Access Compliance Report

Public Rights-of-Way

(Curb Ramps)

Intersection ID: 11344	Main Street: N_TRYON_ST	Cross Street: W_LIDDELL_ST	Location: E
ADA ID: B76147E67F32	Ramp Type: Perp	Initial Pass/Fail: Fail	Overall Compliance: No
Severity Score: 12.5			
Codes/Mitigation Info/Possible Solution		Field Measurements/Component Compliance

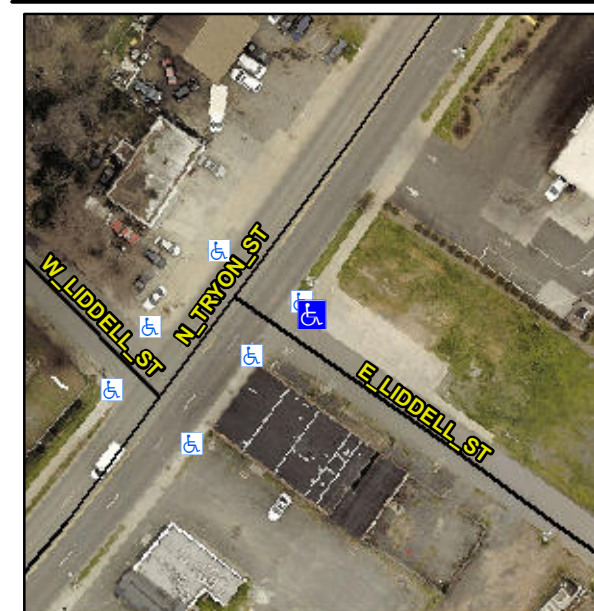
R304.2.2

Compliance	Description	Data	Compliance	Description	Data
N/A	Ramp Length (in)	84.0	No	Ramp Slope (%)	9.2
Yes	Ramp Width (in)	48.0	Yes	Ramp XSlope (%)	1.4
N/A	Flare Type LT	N/A	N/A	Flare Type RT	N/A
N/A	Flare Slope LT (%)	N/A	N/A	Flare Slope RT (%)	N/A
N/A	Flare Traversable LT?	N/A	N/A	Flare Traversable RT?	N/A
N/A	Landing Length (in)	N/A	N/A	DWS Provided?	N/A
N/A	Landing Width (in)	N/A	N/A	DWS Contrast?	N/A
N/A	Landing Slope (%)	N/A	N/A	DWS Length (in)	N/A
N/A	Landing X Slope (%)	N/A	N/A	DWS Full Width?	N/A
N/A	Landing Curb? (Y/N)	N/A	N/A	DWS Offset (in)	N/A
N/A	Shared Landing?	N/A			
N/A	Gutter Ponding?	N/A	N/A	Gutter Slope (%)	N/A
N/A	Gutter Lip Ht (in)	N/A	N/A	Gutter X Slope (%)	N/A
N/A	Painted X Walk1?	No	N/A	Painted X Walk2?	N/A
	X Walk 1 Direction	To SW		X Walk 2 Direction	N/A
N/A	X Walk 1 Width (in)	N/A	N/A	X Walk 2 Width (in)	N/A
	X Walk 1 Slope (%)	5.6		X Walk 2 Slope (%)	N/A
	X Walk 1 X Slope (%)	3.0		X Walk 2 X Slope (%)	N/A

Remove & Replace Entire Ramp.
